UNITED STATES PATENT AND TRADEMARK OFFICE

Office Action Summary	Application No.	Applicant(s)
	10/568,617	WOLFGANG ET AL.
	Examiner	Art Unit
	ANDREW T. KIRSCH	4159

DETAILED ACTION

Fig. 12 of U.S. PG Pub No. 2002/0050493 (Ball et al. hereinafter)

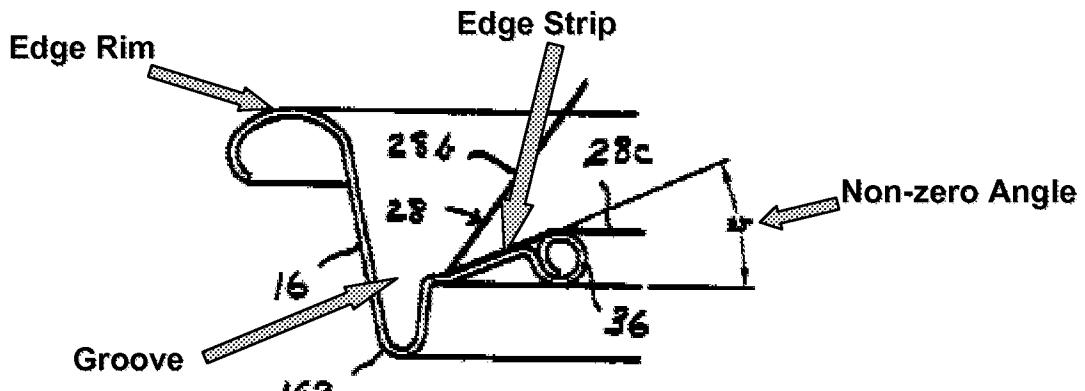
11. In re claim 1, with reference to Figs. 12 and 13 below, Ball et al. discloses: A lever ring for seaming to a body and for receiving a closure layer (28) affixed with an edge by means of sealing (46) and for bridging an inner space of the lever ring, to close the body in a seam-connected position (page 9, paragraph [0095]), wherein (i) the lever ring comprises a continuous flat web (30) which radially outwardly changes into an edge rim (see Fig. 12) of the lever ring, a continuous groove (see Fig. 12) extending between the edge rim and the flat web; (ii) the flat web is suitable for connecting an edge of the closure layer by sealing (page 6, paragraph 73), and extends with respect to a plane of the closure layer (28), that has been connected by such sealing, at an angle (see Fig. 12) differing from zero (page 7, paragraph 76).

13. In re claims 3 and 15, with reference to Fig. 12 above, Ball et al. discloses the claimed invention including wherein the angle differing from zero is between substantially 10° and substantially 90° (see Fig. 12: “23°”).

14. In re claims 5 and 17, with reference to Fig. 12 above, Ball et al. discloses the claimed invention including wherein the angle (α_2) is between substantially 25° and 35° (page 7, paragraph 76).

16. In re claims 9 and 21, with reference to Fig. 12 above, Ball et al. discloses the claimed invention including wherein the flat web (30) comprises radially inwards an inner curling (36).

17. In re claims 10 and 22, with reference to Fig. 12 above, Ball et al. discloses the claimed invention including wherein the closure layer (28) extends on the inner curling (36) and is deflected (ü) so that an edge strip (see Fig. 12) is formed, which extends at

an angle differing from zero (see Fig. 12), with respect to the plane of the closure layer (28) in the inner area of the lever ring.

20. In re claims 14 and 26, with reference to Fig. 12 above, Ball et al. discloses the claimed invention including wherein the groove (see Fig. 12) is of a wedge-shaped design with a rounded bottom and is formed between a chuck wall extending towards the lid rim (2) and the flat web (30) that is oriented in an inclined fashion.

Fig. 13 of U.S. PG Pub No. 2002/0050493 (Ball et al. hereinafter)

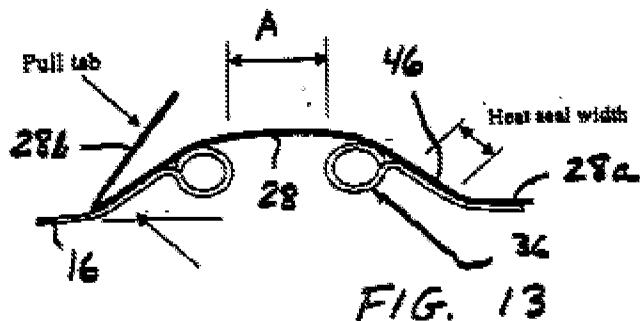
15. In re claims 8 and 20, with reference to Figs. 2A, 4 and 13 above, Ball et al. discloses the claimed invention including wherein said receiving of the closure layer (28) is a sealing of an edge of the closure layer by a sealing strip (46) on the flat web (30) which sealing strip extends circumferentially (page 6, paragraph 74).

19. In re claims 12 and 24, with reference to Fig. 13 above, Ball et al. discloses the claimed invention including wherein the sealing seam as a strip extending circumferentially (46) has a substantial width on the extension of the flat web (30), this width being more than half the width of the flat web.

Figs. 2A and 4 of U.S. PG Pub No. 2002/0050493 (Ball et al. hereinafter)

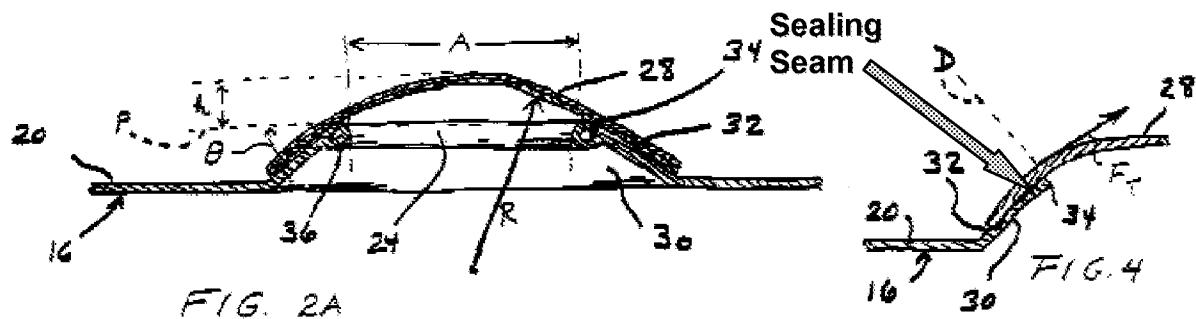
12. In re claim 2, with reference to Figs. 12 and 13 above and 2A and 4 below, Ball et al. discloses: A lever ring for seaming to a body and for receiving a closure layer (28) affixed with an edge by means of sealing (46) and for bridging an inner space of the lever ring, to close the body in a seam-connected position (page 9, paragraph [0095]), wherein (i) the lever ring comprises a continuous flat web (30) which radially outwardly changes into an edge rim (see Fig. 12) of the lever ring, a continuous groove (see Fig. 12) extending between the edge rim and the flat web; (ii) the flat web (30) extends upwardly inclined from a horizontal plane and is provided with an inner curling (36) on its radially inner end so that a closure layer (28) affixed to it by sealing introduces a substantial force component (F_T) into a sealing seam (46), so that the force component extends in an extension direction of the sealing seam, upon a pressure force acting vertically to a plane of extension of the closure layer (page 7, paragraph 84).

Fig. 2 of U.S. Patent No. 6,082,944 (Bachmann et al. hereinafter)

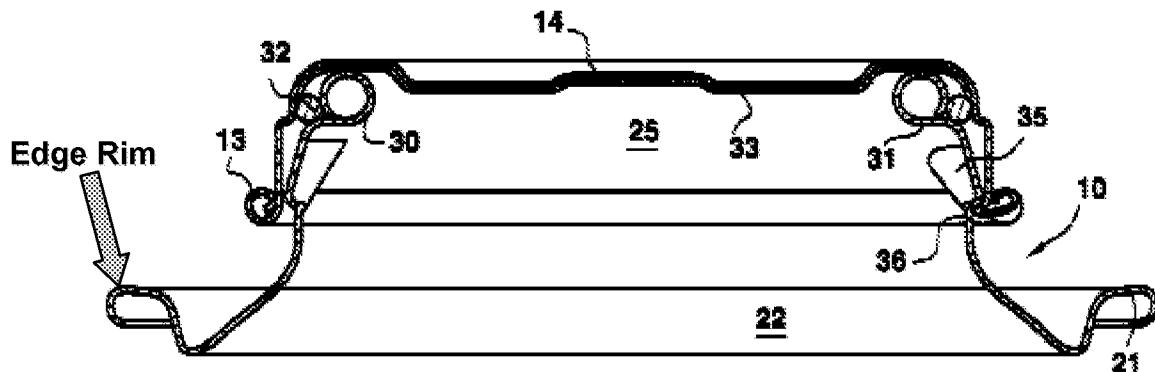
37. However, with reference to Fig. 2 below, Bachmann et al. discloses a can end configuration with a removable closure layer (14), in which an inner curling (30) axially projects above an upper side of the lid rim (see Fig. 2).

38. Therefore, it would have been obvious to one of ordinary skill in the art at the time of the invention to have modified the curl of Ball et al. to be elevated in relation to the upper side of the lid rim as taught by Bachmann et al. Such a modification would have allowed for improved mouth construction for better pouring and drinking comfort (column 2, lines 15-23).
